Project: Greater Karachi Bulk Water Supply Scheme, Phase-I, K-IV
Project, (260 MGD)

Subject: SUBMISSION OF FINAL DESIGN REVIEW REPORT ALONG
WITH ANNEXURES BY M/S. NESPAK FOR THIRD PARTY
DESIGN REVIEW OF K-IV PROJECT.

Karachi WTS third party review

Hydraulic analysis & simulations

Figure 2.4 Steady-state (maximum design discharge) and minimum/maximum head envelope for the rising main 1 during a full pump trip.

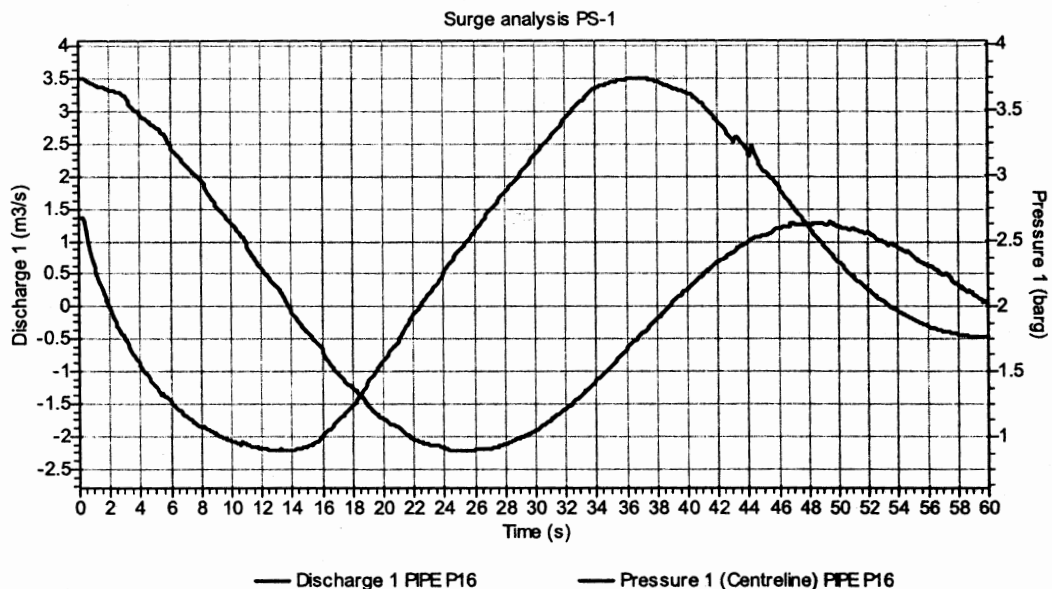
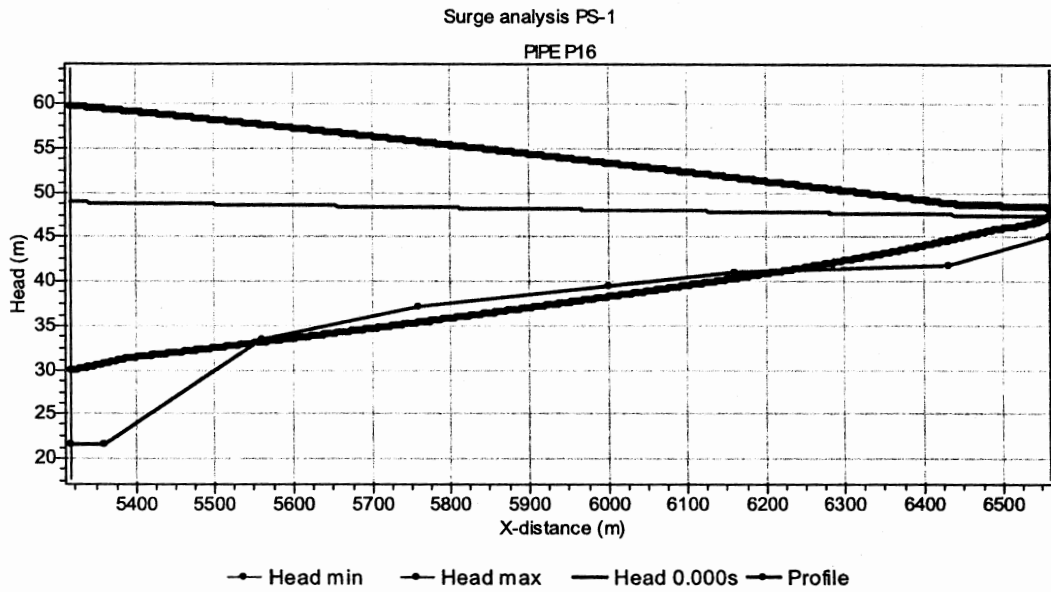
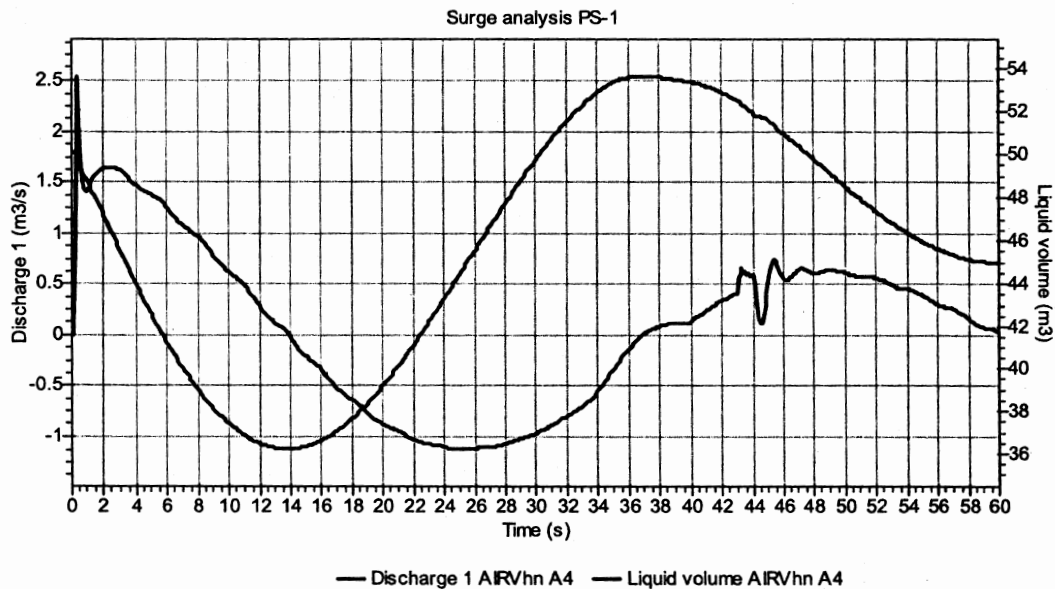
After the pumps trip, a negative pressure surge propagates from the pumps into the rising main and pneumatic vessels. The pneumatic vessels react to this by discharging into the manifold, which causes the check valves to close. When the check valves are closed, the discharge from the pneumatic vessels propagates into the rising main, preventing negative pressures. When the pressure surge reaches the forebay it is reflected and travels back to the pneumatic vessels. The water level in the pneumatic vessels decreases due to the discharge into the rising mains, causing the pressure in the pneumatic vessel to decrease. The low pressure in the pneumatic vessels causes the liquid column in the rising main to decelerate and reverse flow direction. The reverse flow causes the water level in the pneumatic vessels to rise (refilling), increasing the pressure. When the pressure reaches the set point of the pressure relief valve, it briefly opens and discharges into the pump sump. The pressures in the rising main and pump manifold remain well within acceptable limits.

From the simulation results discussed in the previous chapter, it is concluded that the surge protection as specified in the pumping station design report suffices to protect the pumping stations and rising mains during a full pump trip.

However, the design allows for optimization of the surge protection because the current surge protection equipment (pneumatic vessels and pressure relief valves) are larger than what is necessary.

Figure 3.1 Head envelope of Canal Reach 2 and siphons for a discharge of 260 MGD (13.4 m³/s)

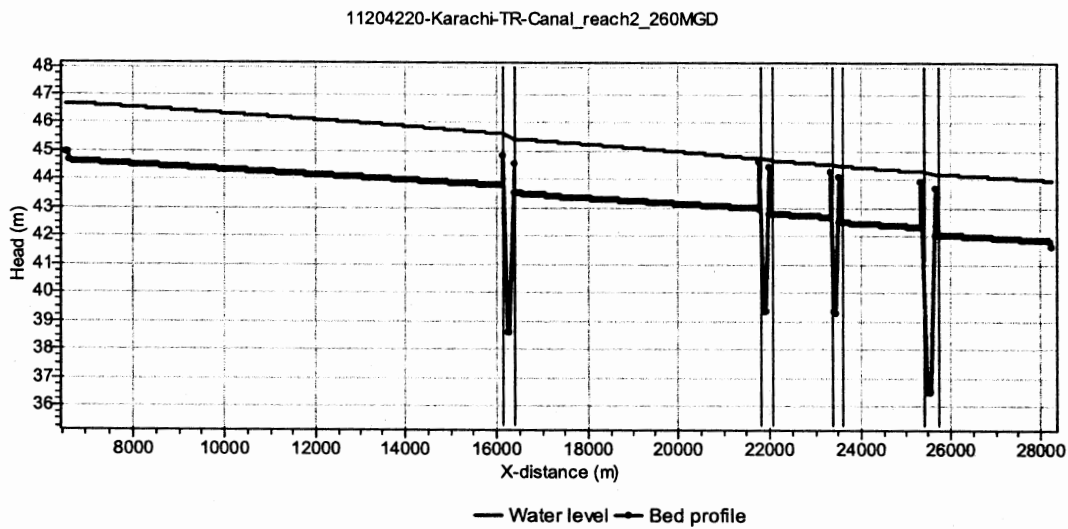
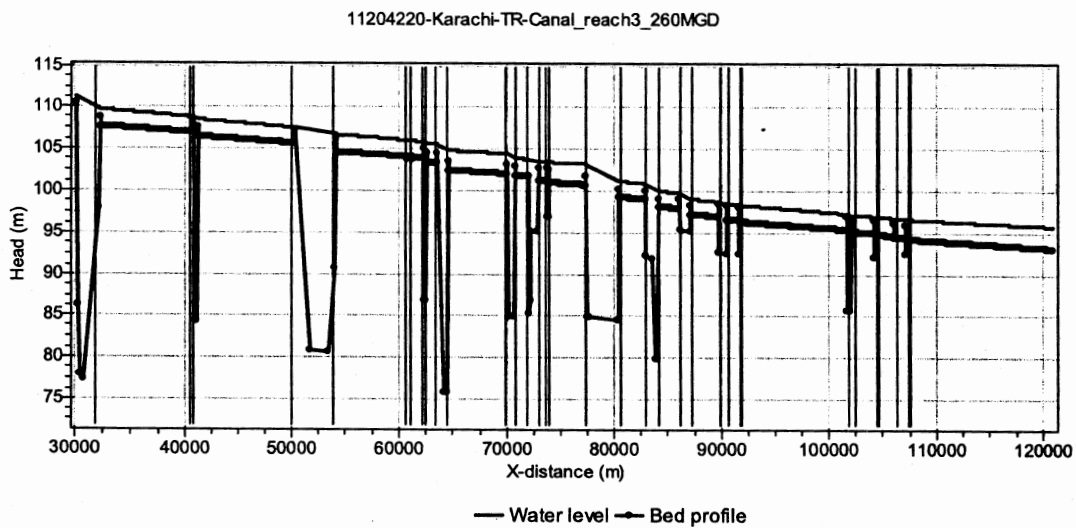
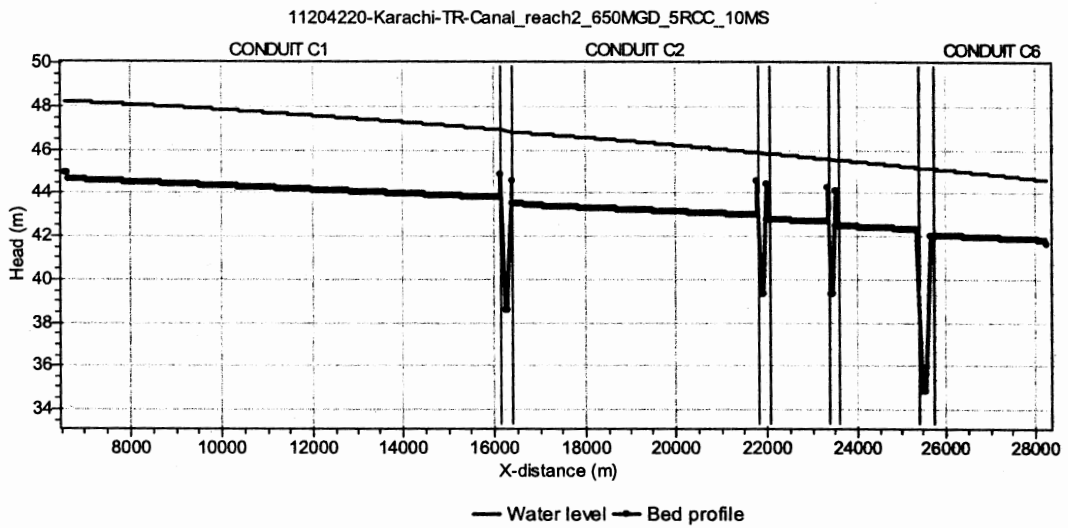
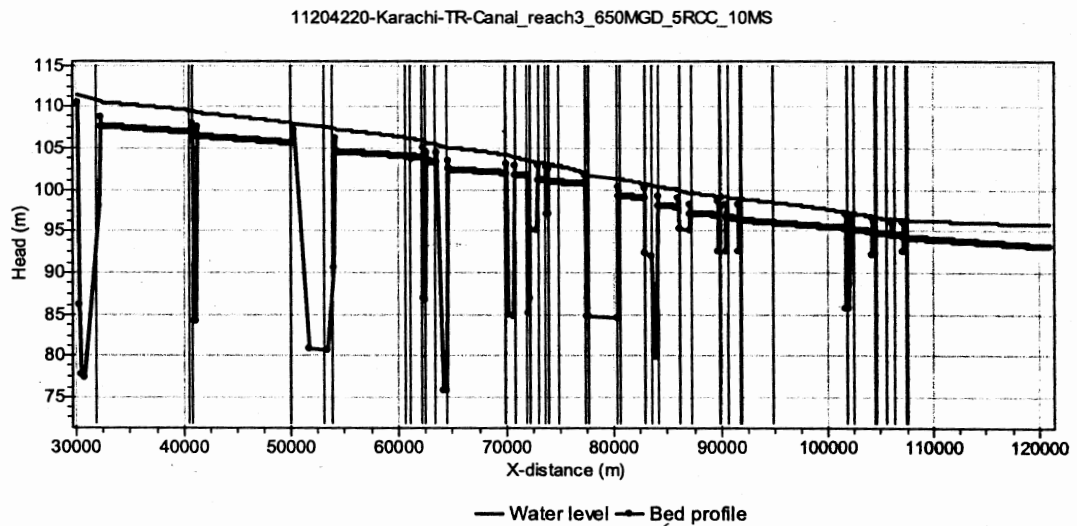
The results from these simulations have been used to verify and confirm the hydraulic calculations performed by NESPAK. There are small differences in the calculation results from Deltares and NESPAK. These differences have been analysed and discussed with NESPAK engineers and our mutual conclusion is that these differences are negligible and are caused by the differences in the numerical modelling methods that were used.

The conclusion is that the design flow rate of 260 MGD and 650 MGD can be transported by the canals and siphons. The water levels in the canal are within acceptable limits.

A preliminary assessment of the risk of sedimentation in the siphons indicates that the flow velocity in the siphons is not sufficient to transport medium and coarse sediments. Fine

This analysis should have been performed during the initial design phase of the project and mitigating measures could have been incorporated into the original design. It is highly recommended to perform additional analysis and studies regarding sediment transport through the canals and siphons and design mitigating measures where required, as these aspects directly affect the reliability and the hydraulic capacity of the system.
